REMARKS

AMENDMENTS TO THE DRAWINGS

Title: WAVELENGTH DIVISION MULTIPLEXED DEVICE

Serial Number: 09/940554

33
F/G.

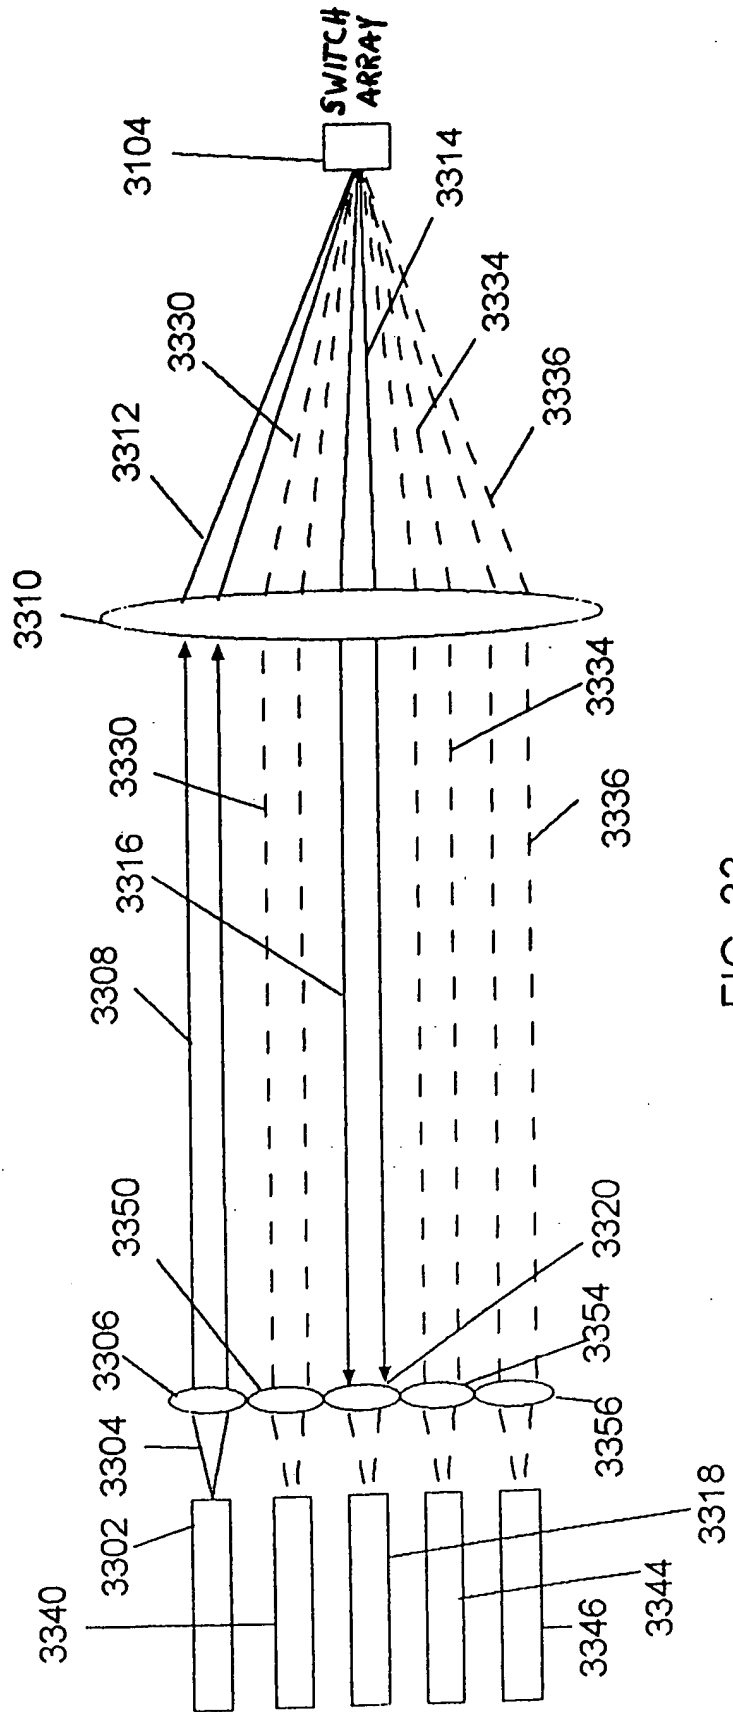
- This sheet, which contains FIG. 28, replaces the original sheet that contains FIG. 28. In FIG. 28, box 2430 has been labeled LIGHT HANDLING UNIT.
- This sheet, which contains FIGS. 31, 32 and 33, replaces the original sheet that contains FIGS. 31, 32 and 33. In FIG. 31, box 3104 has been labeled SWITCH ARRAY. In FIG. 32, boxes 3108 and 3203 have been labeled SWITCH and REFLECTOR respectively. In FIG. 33, box 3104 has been labeled SWITCH ARRAY.

FIG. 34

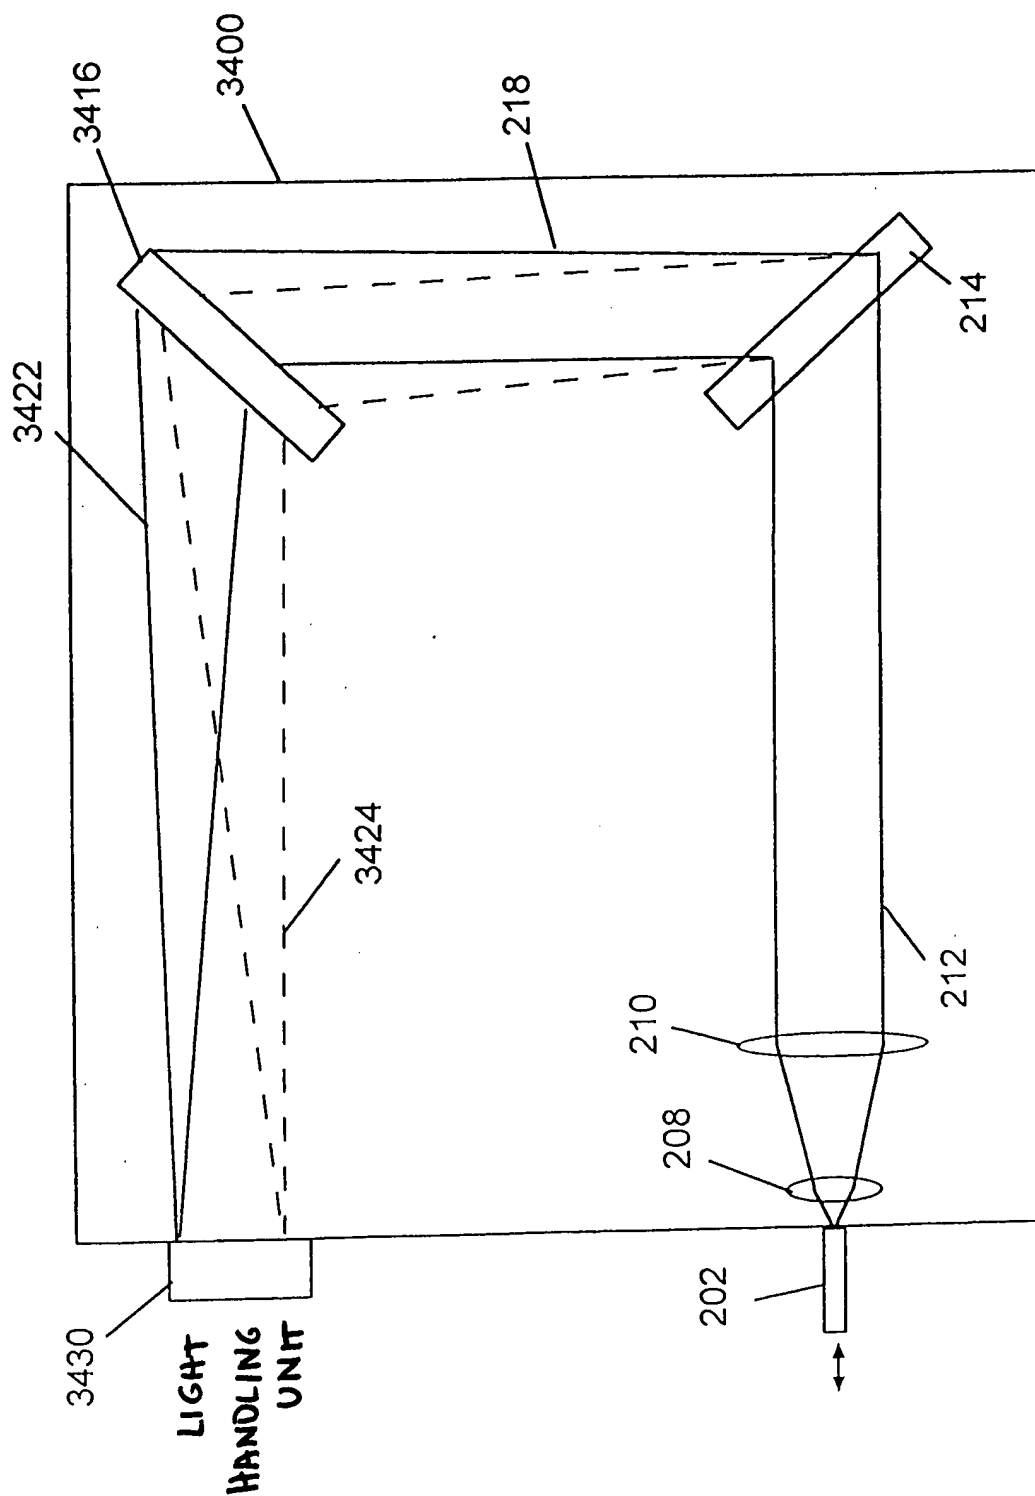
- This sheet, which contains FIG. 34, replaces the original sheet that contains FIG. 34. In FIG. 34, box 3430 has been labeled LIGHT HANDLING UNIT.
- This sheet, which contains FIGS. 36A and 36B, replaces the original sheet that contains FIGS. 36A and 36B. In FIG. 36A, boxes 3630 and 3632 have been labeled ATTENUATING REFLECTIVE ARRAY and ATTENUATING REFLECTORS respectively. In FIG. 36B, box 3630 has been labeled ATTENUATING REFLECTIVE ARRAY.

FIG. 39

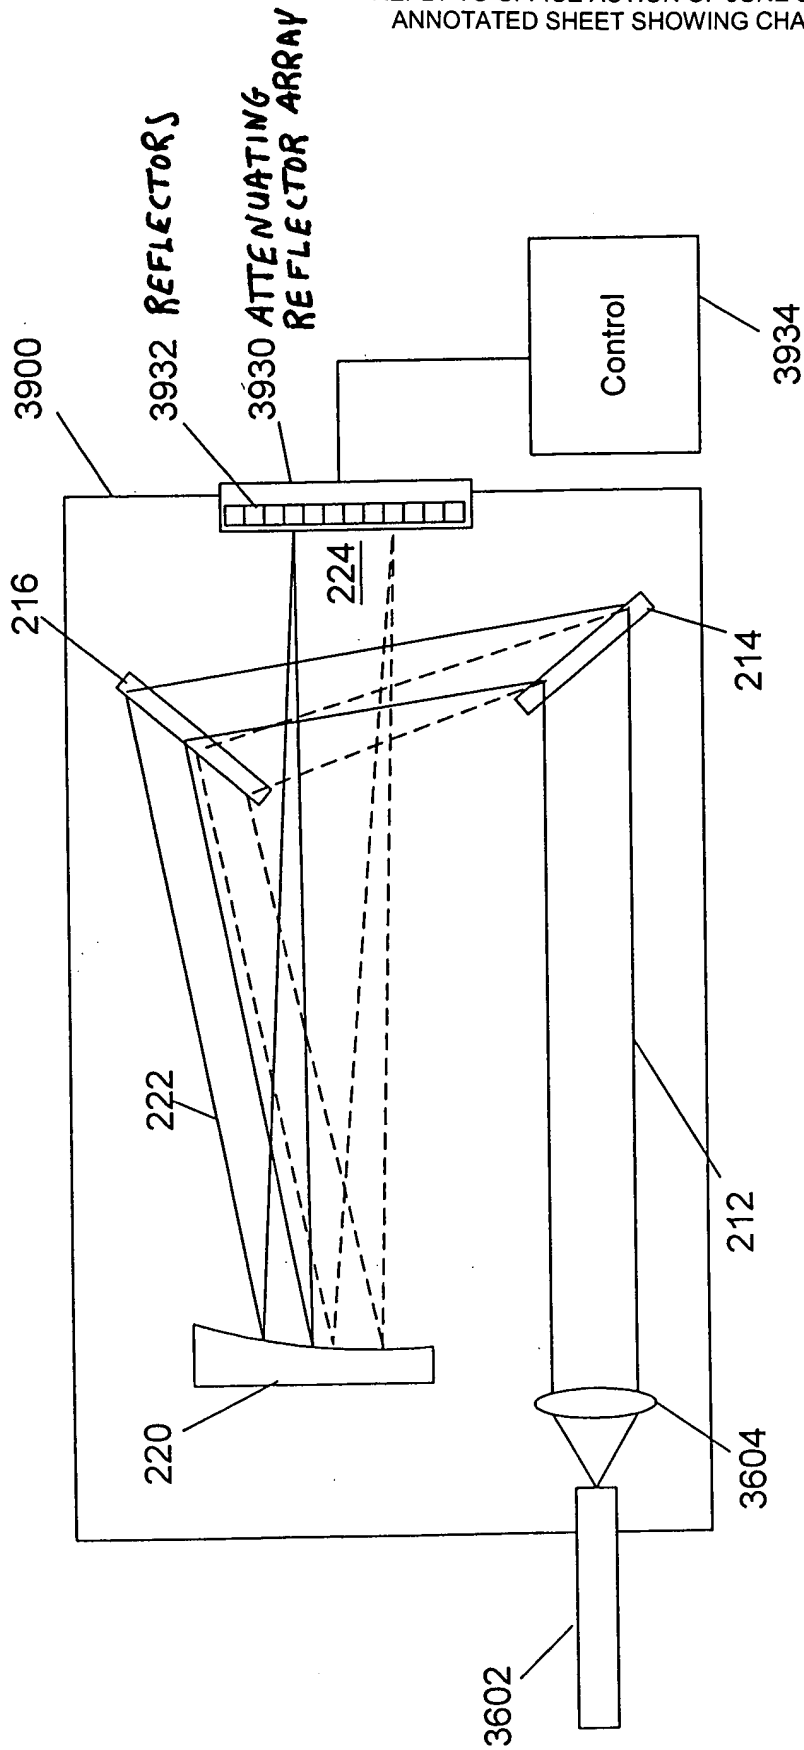
- This sheet, which contains FIGS. 39 and 40, replaces the original sheet that contains FIGS. 39 and 40. In FIG. 39, boxes 3930 and 3932 have been labeled ATTENUATING REFLECTOR ARRAY and REFLECTORS respectively.
